Property Alliance Group / Starwood Capital Group Renaissance Site

Residential Building Section 73 Application (141175/JO/2024)

Issue No. 03 23.10.25

5.2 Masterplan Ground Floor Plan
S73 Proposal

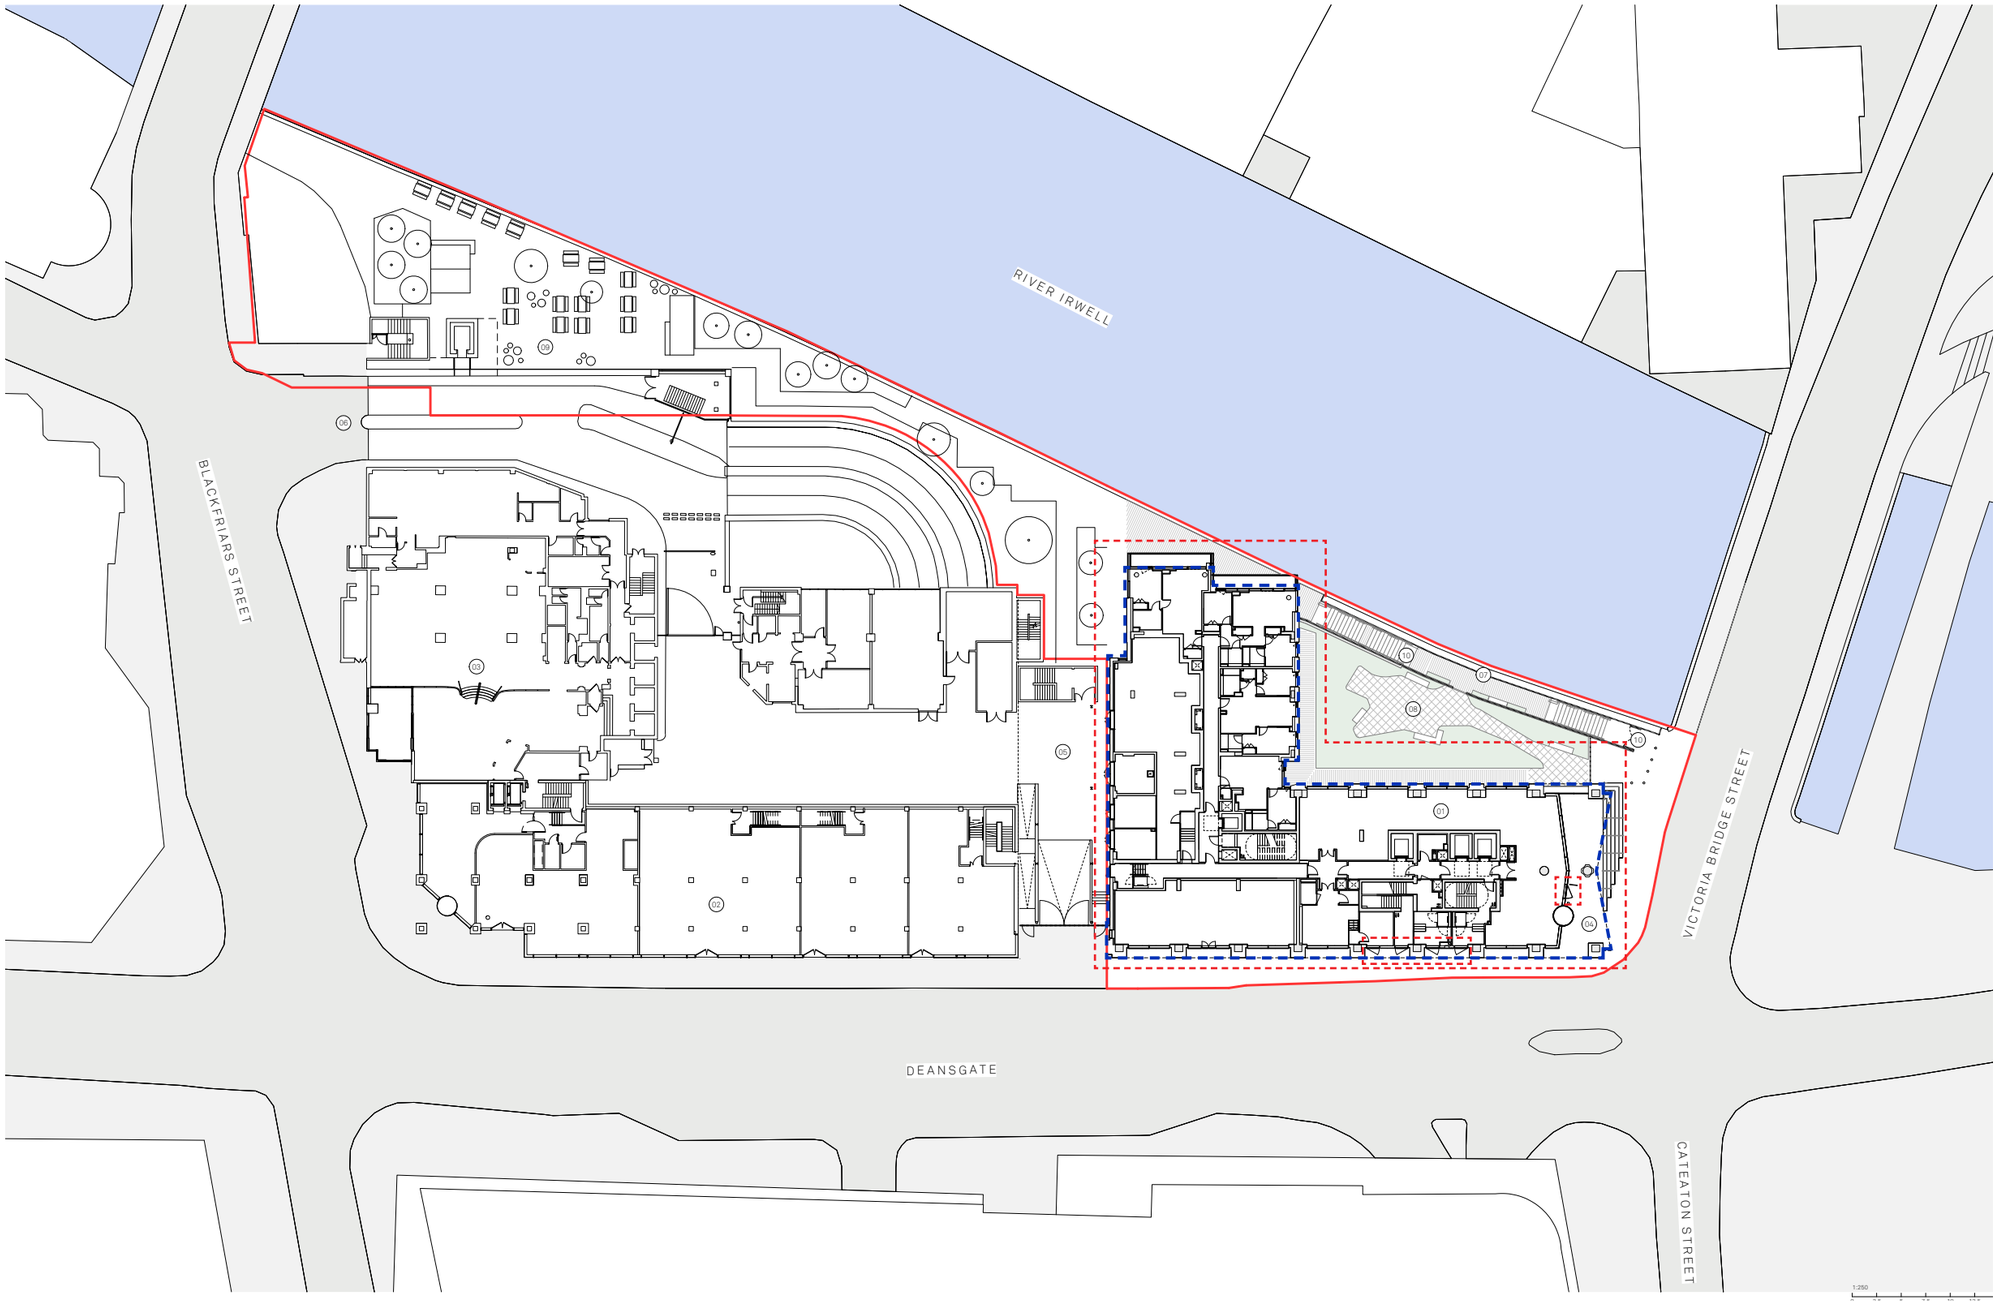
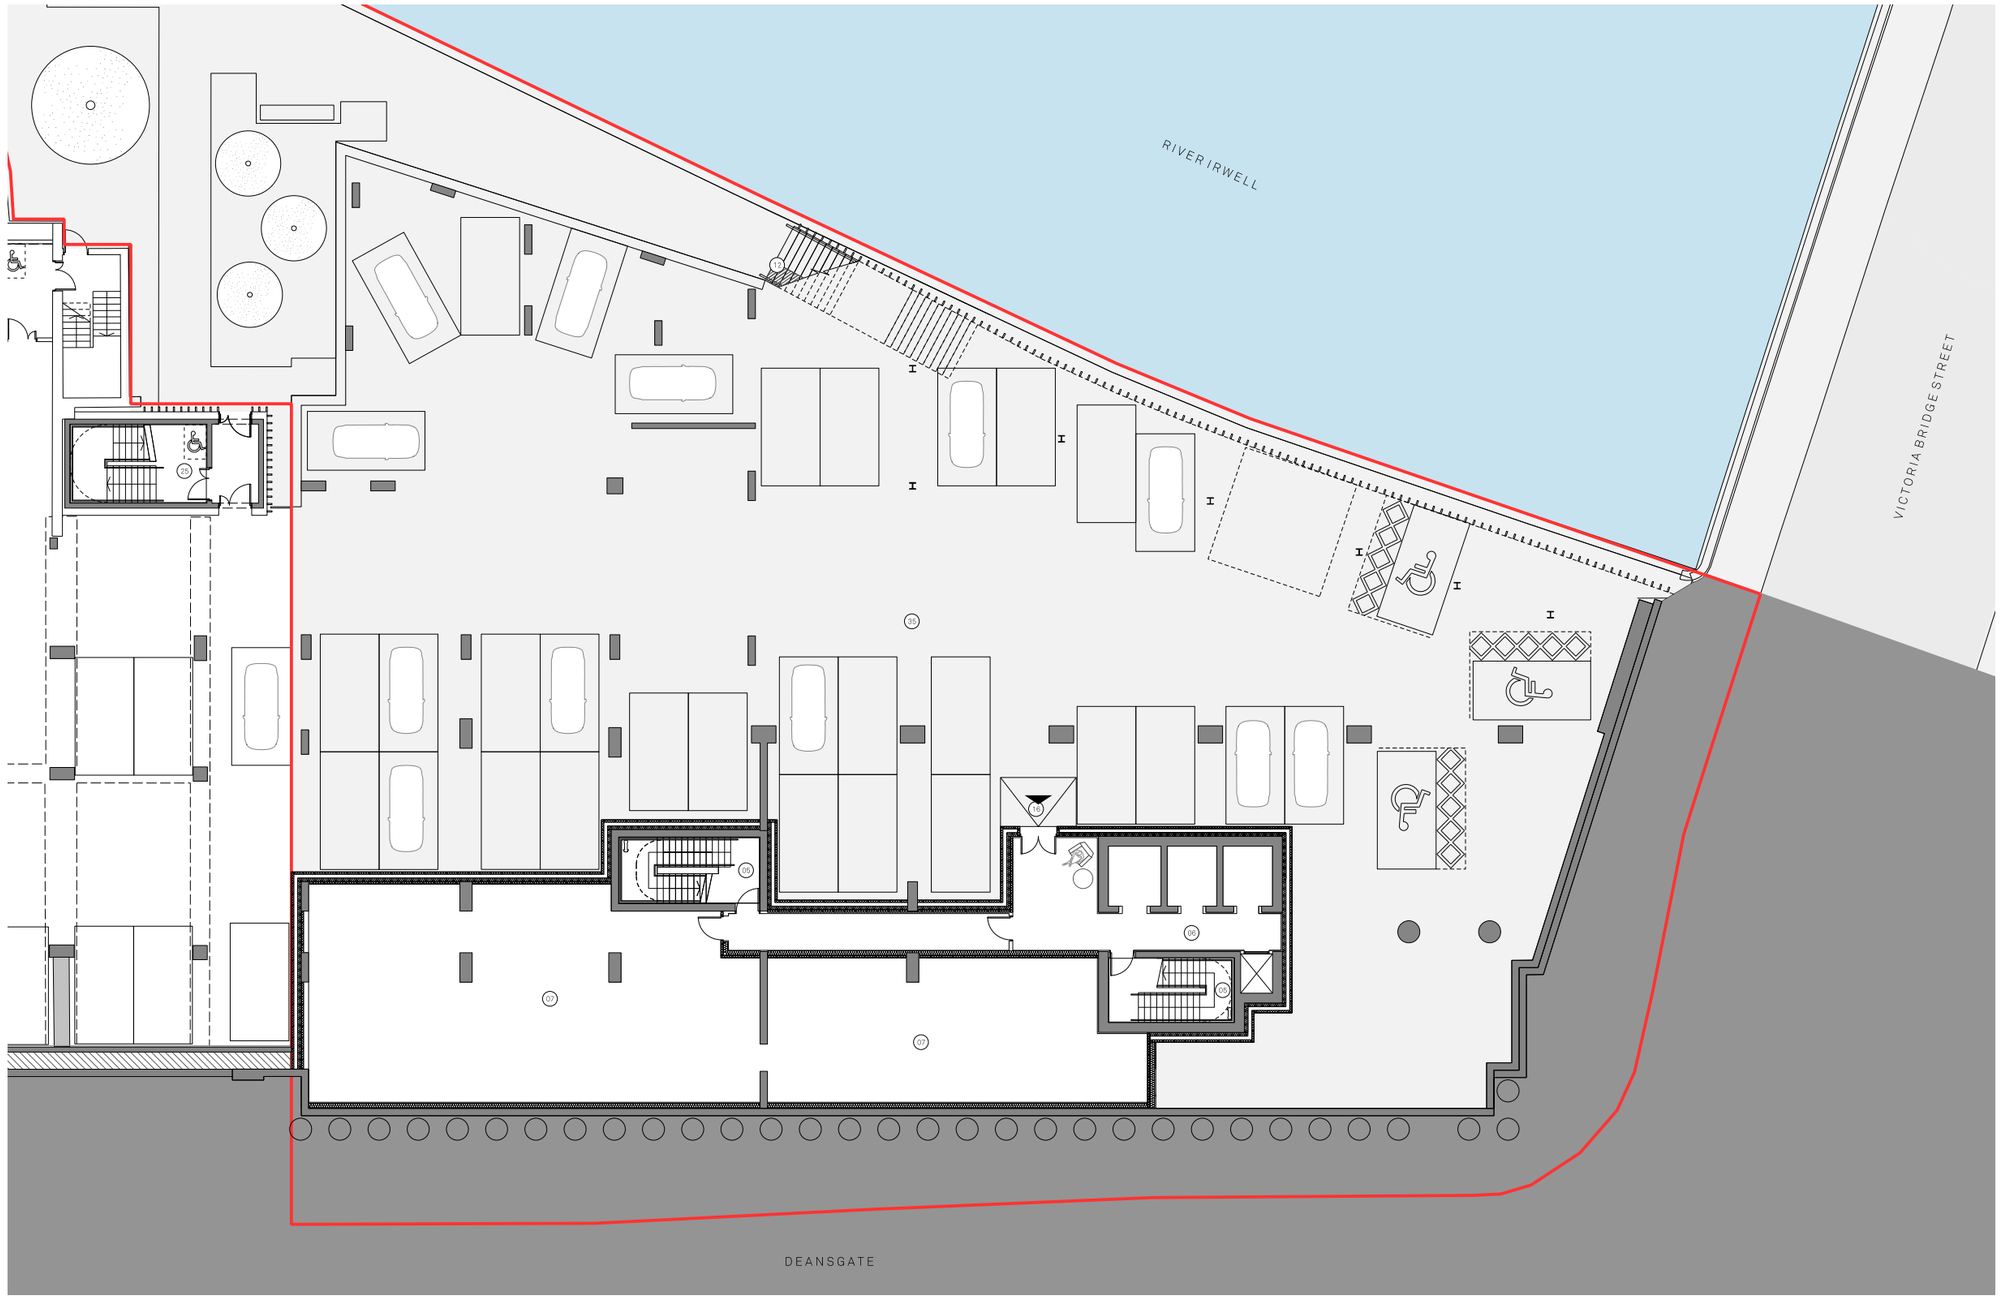
Sept 2024 Amendments:
(141175/JO/2024)
- Fire-fighting lobby added to all floors with an +1 additional stair and evacuation lift plus associated fire fighting lobbies.

Current Proposed Amendments 2025:
- Spatial reconfiguration of amenity, plant, operation and service rooms.
- All apartment layouts amended.

5.2 Lower Ground -02
S73 Proposal

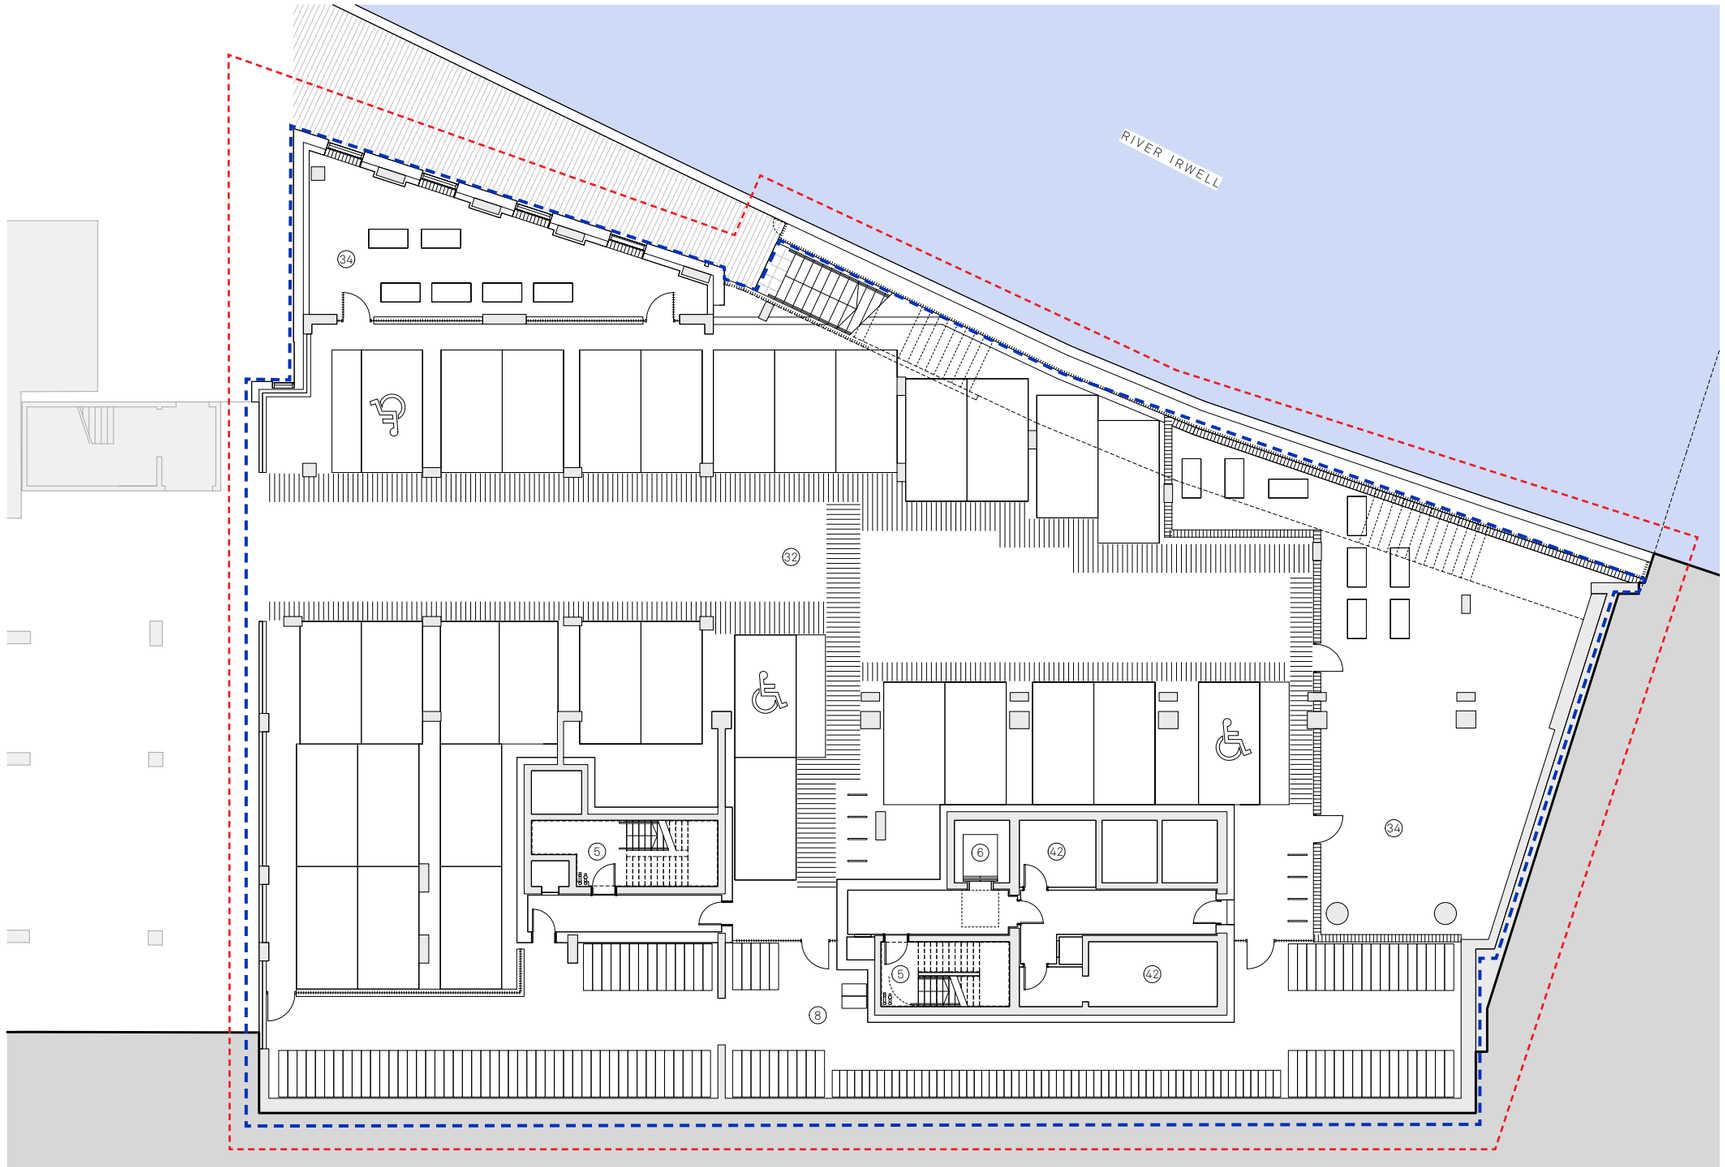
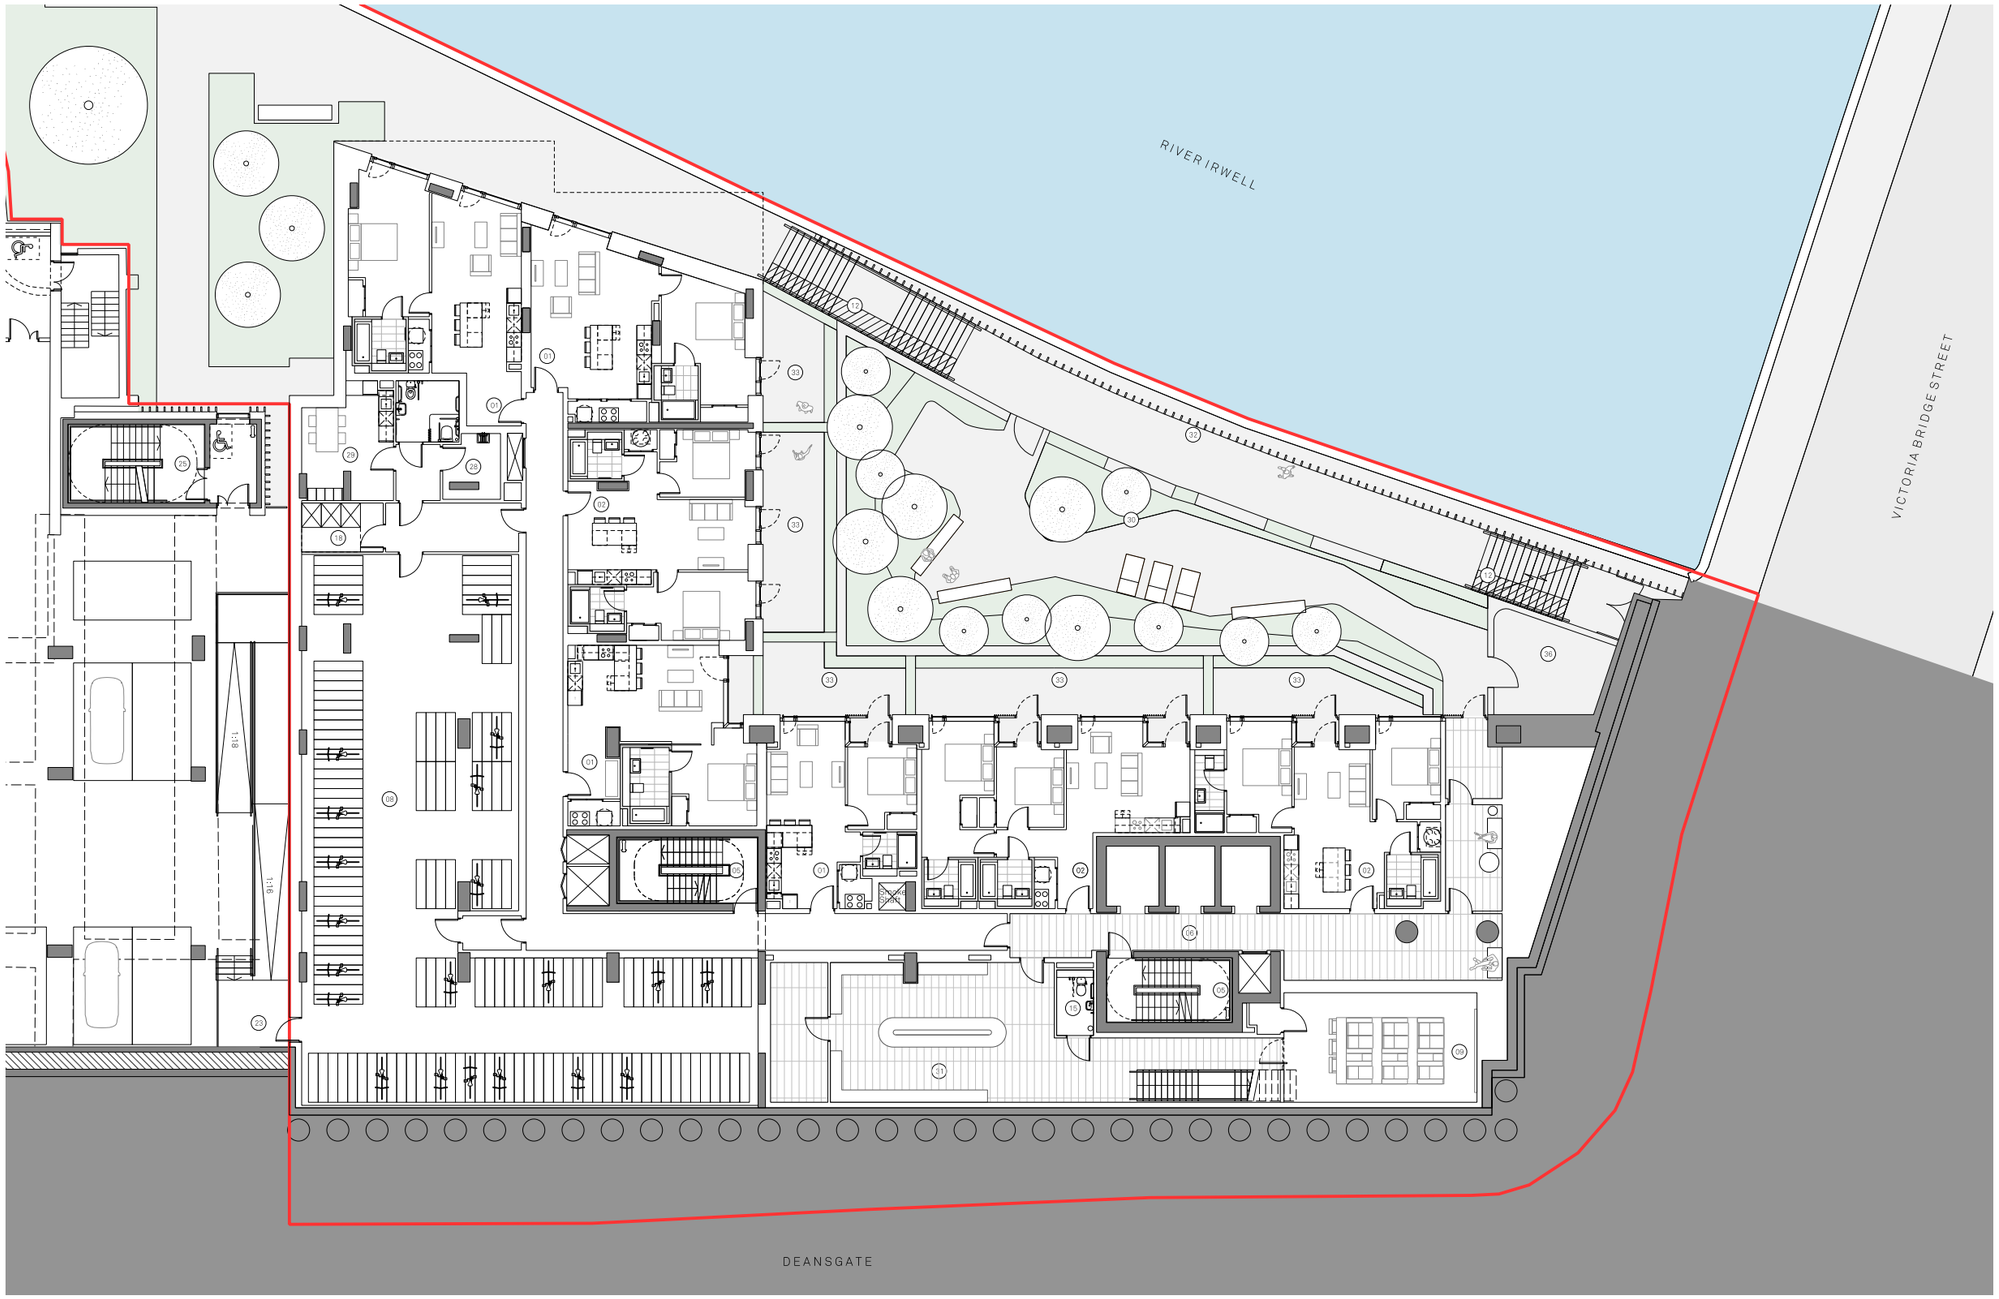
Sept 2024 Amendments:
(141175/JO/2024)
- Fire-fighting lobby added to all floors with an +1 additional stair and evacuation lift plus associated fire fighting lobbies.

Current Proposed Amendments 2025:
- Cycle store moved to lower-ground 2 from lower-ground 1
- Re-configuration of car park layout. Parking bays reduced from 34 to 31
- Plant rooms added
